SUBJECT: REQUEST FOR ADDITIONAL INFORMATION (RAI) ON HIGH TEMPERATURE MATERIALS GRAPHITE; CONTROL OF CHEMICAL ATTACK; AND DESIGN CODES AND STANDARDS FOR THE PEBBLE BED MODULAR REACTOR (PBMR)

Project No. 713

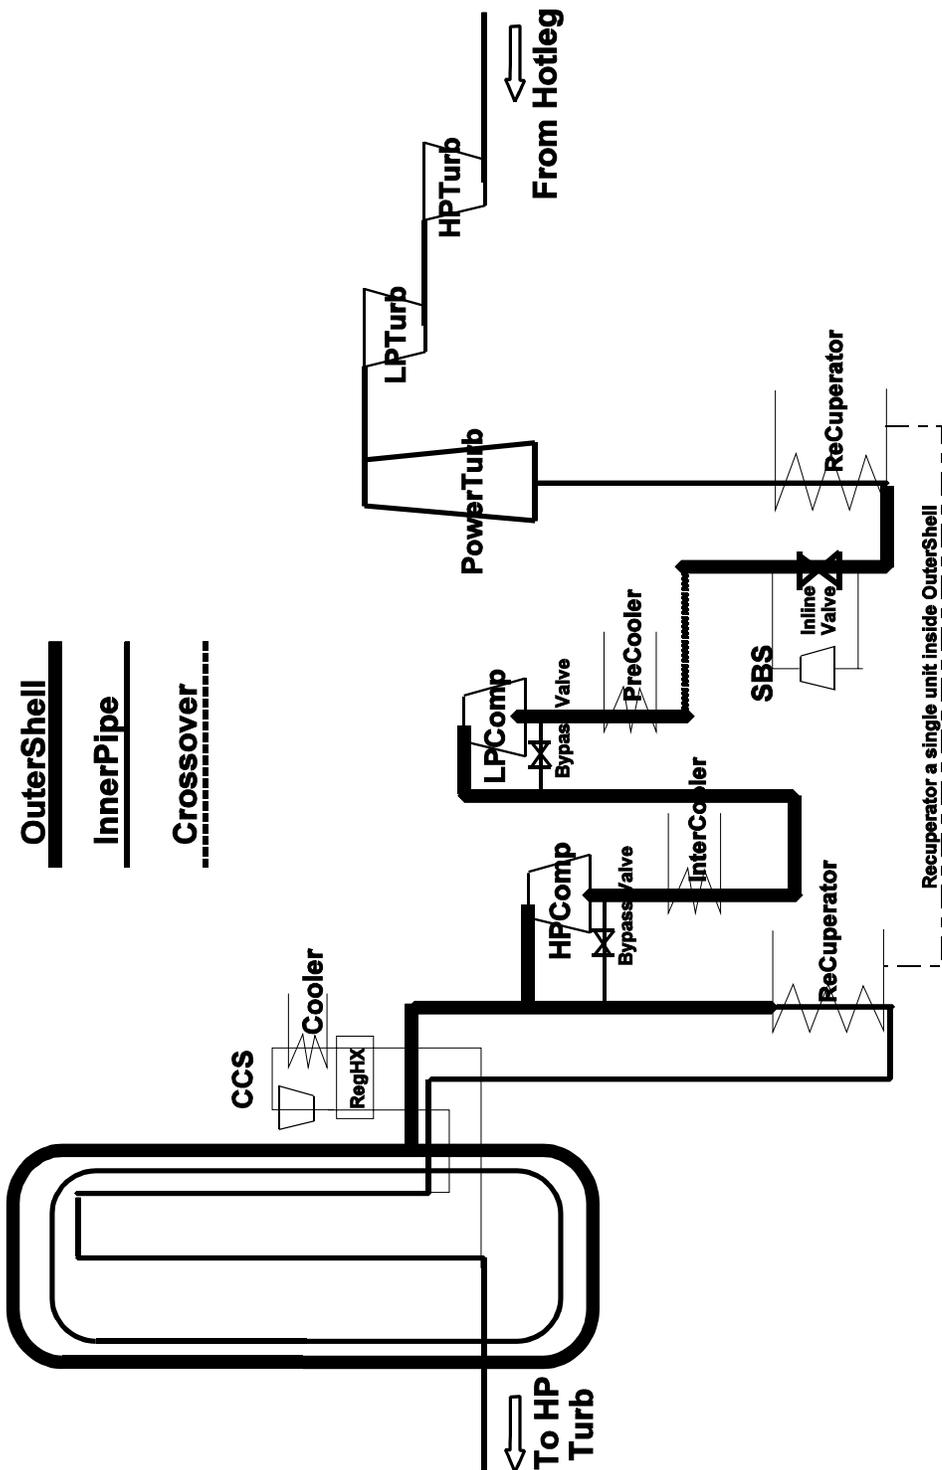
The attached figure shows relative system elevations (not necessarily to scale) and locations of various heat sinks (coolers) of the PBMR piping. Note, the actual piping of the PBMR is pipe within a pipe (concentric) with hot gas on the inside and cooler gas on the outside. The attached figure was an attempt to lay this out in a linear fashion to better visualize the flow path and elevations.

It is not obvious that the “diving bell” characteristic or the inverted manometer with equal pressure at the bottom openings of the hot leg and cold leg is always the correct assumption. Given the complicated piping system of inner and outer pipes, and the large elevation differences within the piping system, these factors need to be addressed.
